HOWARD COUNTY HISTORIC PRESERVATION COMMISSION

HPC EXECUTIVE SECRETARY EXEMPTION DETERMINATION FOR MINOR ALTERATIONS AND TAX CREDIT PRE-APPROVAL

APPLICANT INFORMATION:	PROPERTY INFORMATION:
James Stewart 3801 Old Columbia Pike Ellicott City, MD 21043	Property Address: 3801 Old Columbia Pike, Ellicott City
	Minor Alteration Case Number: MA-21-40
	Property Information: Map 251, Parcel 316
OWNER INFORMATION:	HISTORIC DISTRICT INFORMATION
James and Elizabeth Stewart 3801 Old Columbia Pike Ellicott City, MD 21043	Ellicott City Historic District <input checked="" type="checkbox"/>
	Lawyers Hill Historic District <input type="checkbox"/>

Amendment to Previously Approved HPC-20-54

1 attic floor with roof framing plan
scale: 1/4" = 1'-0"

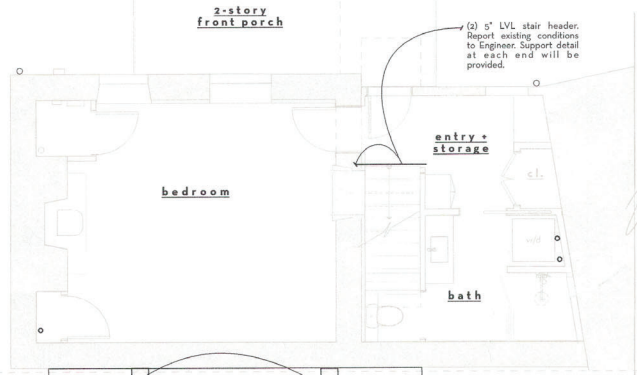
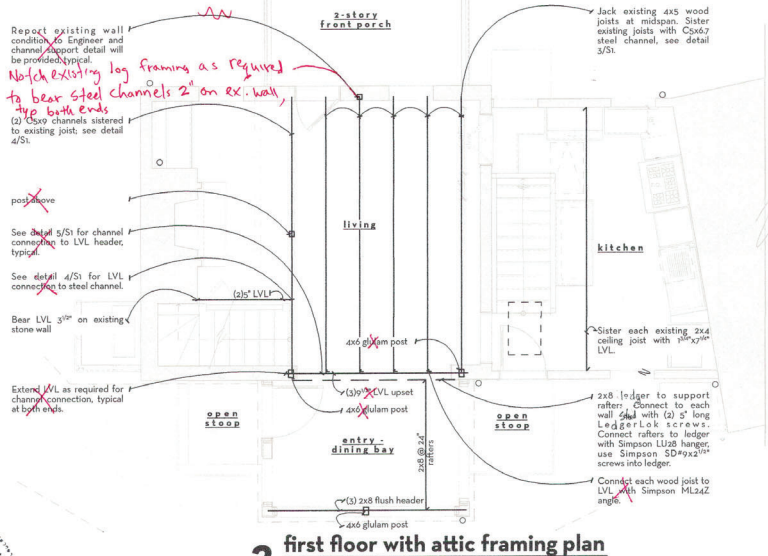
1. The ridgebeam that the replacement dormer rafters will hang from must extend the full length of the roof in order to adequately support the entire roofing system. It has been determined that multiple collar ties were improperly severed on the western end of the roof at some point prior to purchasing the home. The lack of properly functioning collar ties does not provide adequate support for that end of the roof, which compromises the structural integrity of the entire roof. Extending the ridgebeam to the chimney will provide sufficient structural support for the entire roof, in spite of the nonfunctional ties. **See updated technical drawings from engineer.**

Description: Extension of previously approved ridgebeam - See updated structural drawings from
engineer.

1 rear views
not to scale

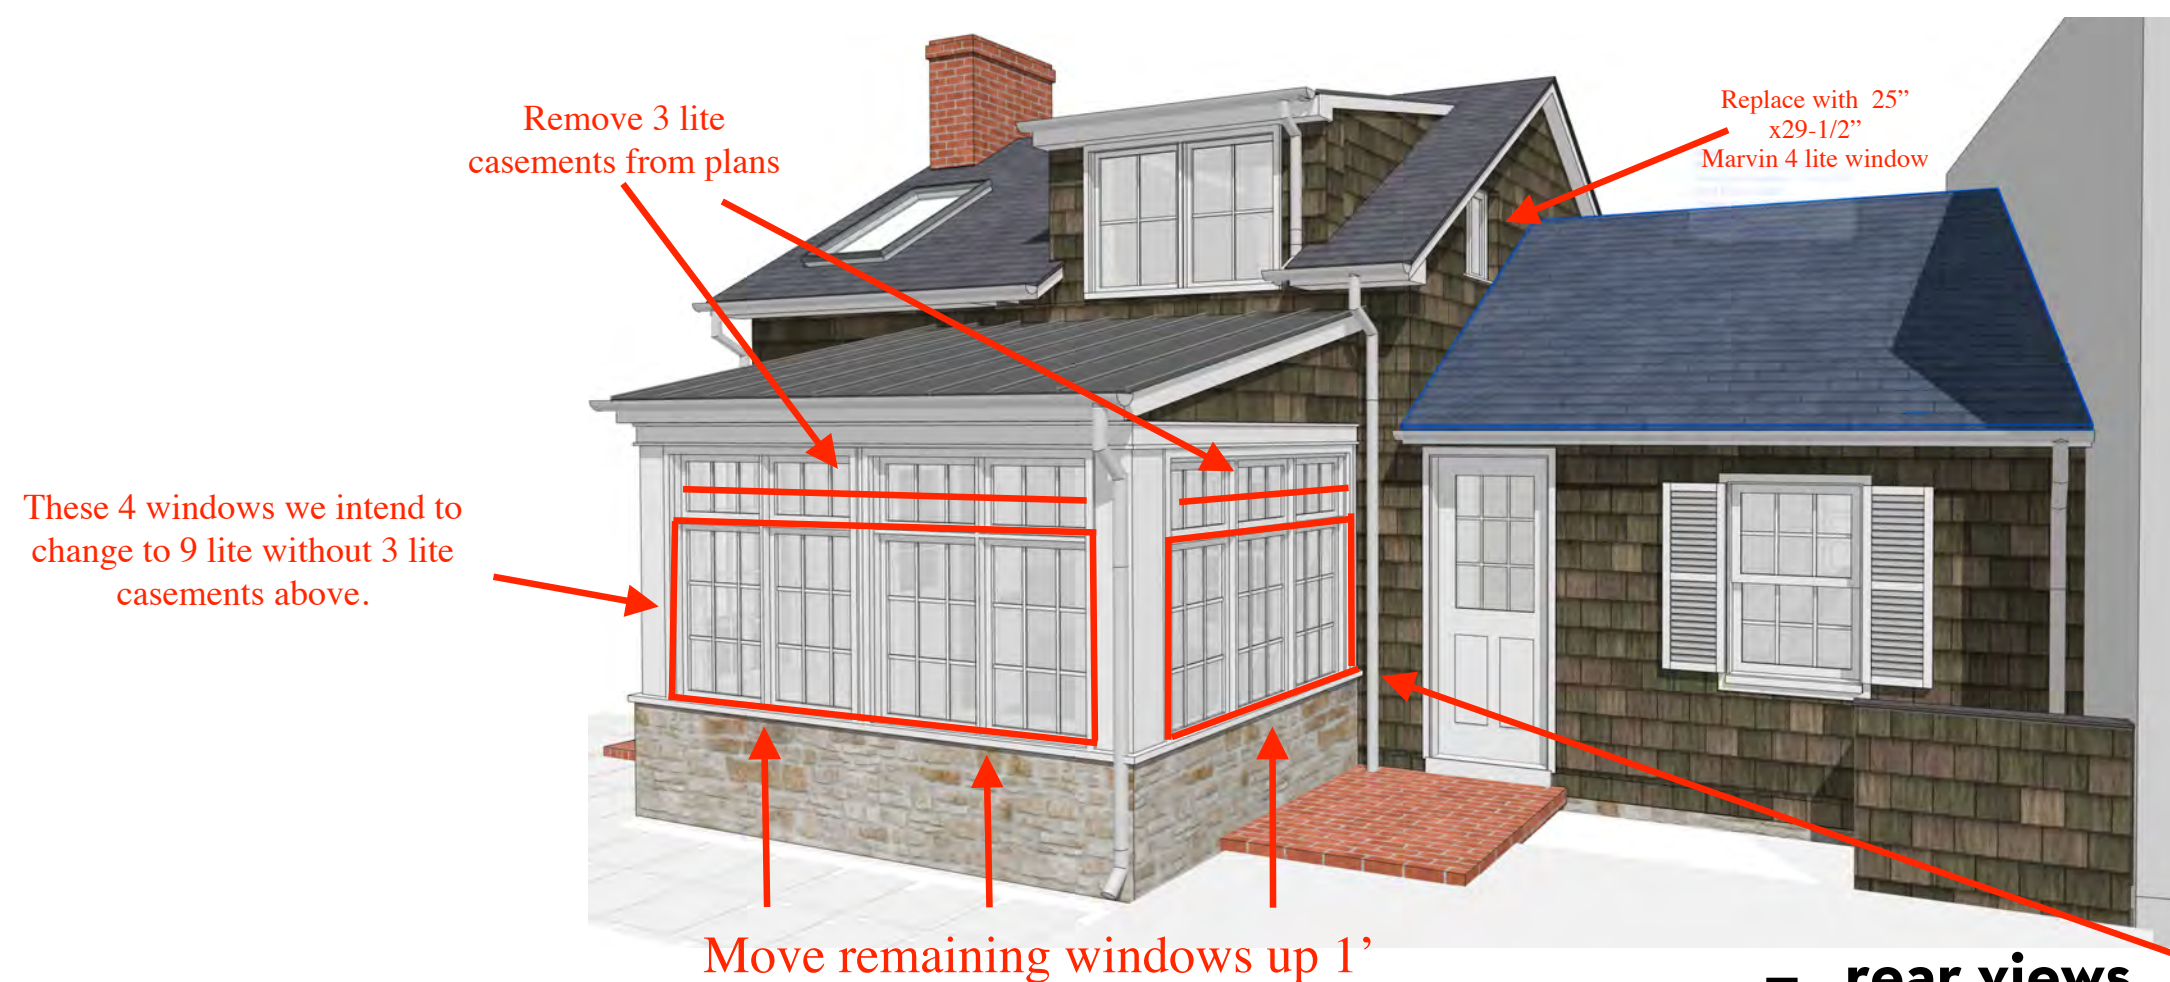
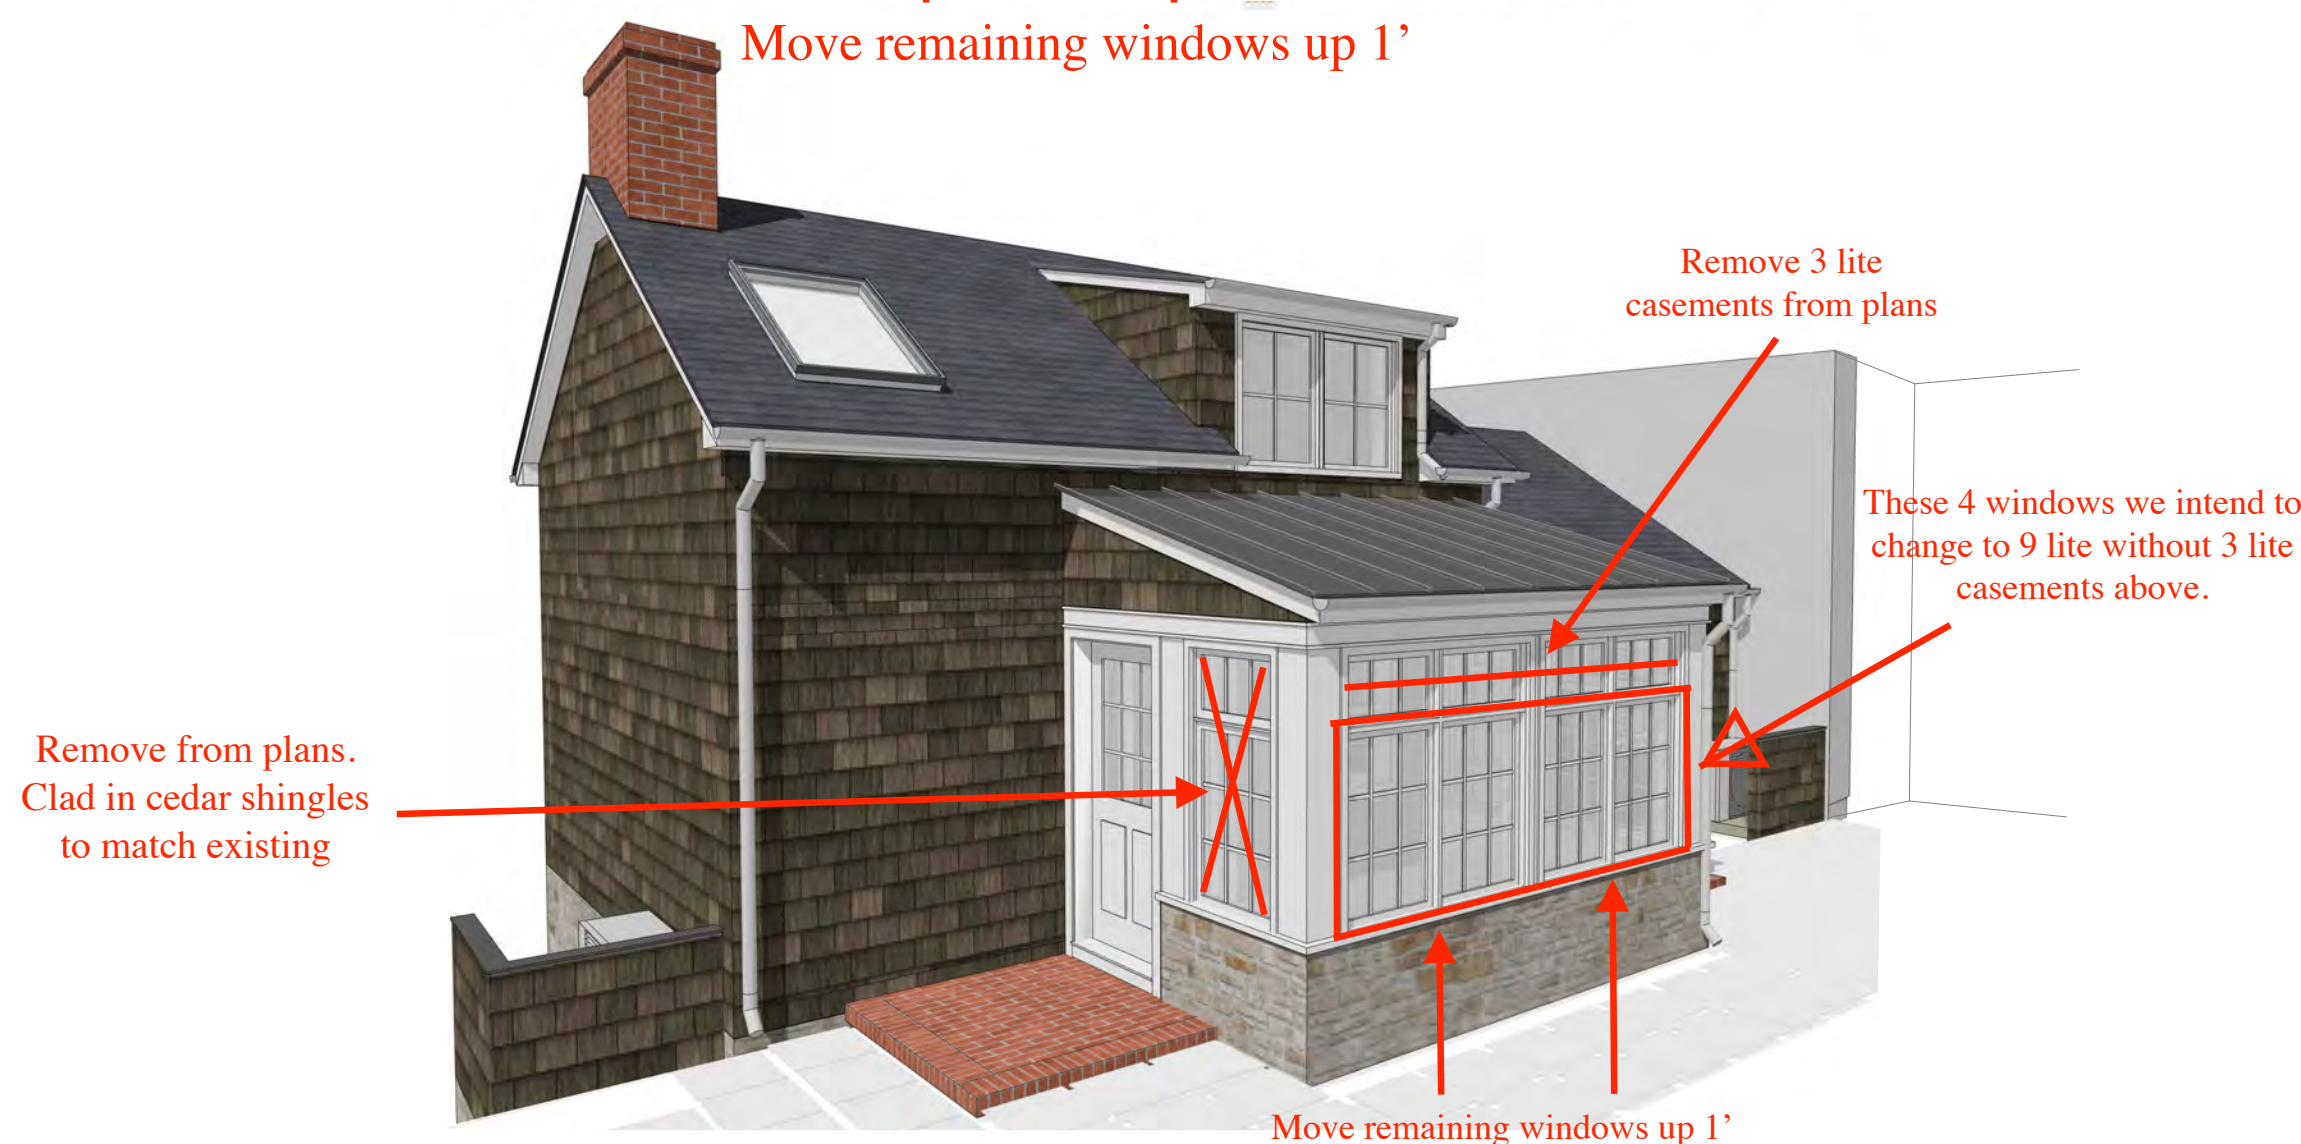
Move remaining windows up 1'

These 3 windows we intend to change to 9 lite without 3 lite casements above.

3. We have decided to make small modifications to the window configuration in the new "entry - dining bay" addition that was previously approved. We no longer want to have a single window (W3 on previously approved drawings) next to the door, and will leave that wall solid, clad in cedar shingles to match existing siding. We also decided to install smaller windows, similar in size to the existing double hung windows) in the rest of the addition. The configuration will remain the same as in the drawings for windows W4 and W5, but the fixed 3 lite glass will be removed from the top of the casement, resulting in windows that are 1'1" shorter than the previously approved windows. The windows will be shifted up 1' higher on the wall to account for the difference. **See attached technical drawings for updated "entry - dining bay" windows. See "modified drawings for windows" file for deviations from previously approved drawings.**

Line #7	Mark Unit:	Net Price:		1,114.46
Qty: 2		Ext. Net Price:	USD	2,228.92

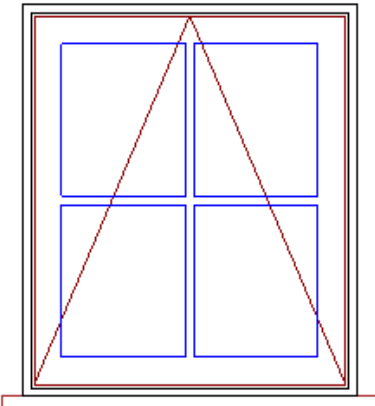
2. After removing 2 french casement windows from the attic for restoration, it has been determined that those windows are not historic (**see letter from Corners Historic Restoration**). Additionally, the 38" height of the windows places them too close to the adjacent hyphen roof. Being so close to the adjacent roof does not allow for adequate roof/wall flashing, which has led to significant damage to the surrounding logs due to water intrusion. We propose replacing the non-historic french casement windows with smaller period appropriate 4 lite windows that better match the existing historic double hung windows. The smaller windows will allow more space between the window sill and adjacent hyphen roof, to provide adequate flashing, and prevent future log damage. **See attached technical drawing for proposed "attic" windows. See "modified drawings for windows" file for deviations from previously approved drawings.**

X7	1	Existing			2'-7"	4'-0"		
	X10	1	Existing			2'-6 3/4"	4'-0"		
	X11	1	Existing			2'-7"	2'-4"		
	X12	1	Existing			2'-2"	2'-6"		Replace with 25"x29-1/2" Marvin 4 lite window
	X13	1	Existing			2'-2"	2'-6"		Replace with 25"x29-1/2" Marvin 4 lite window
	Z	1				2'-7"	5'-0"
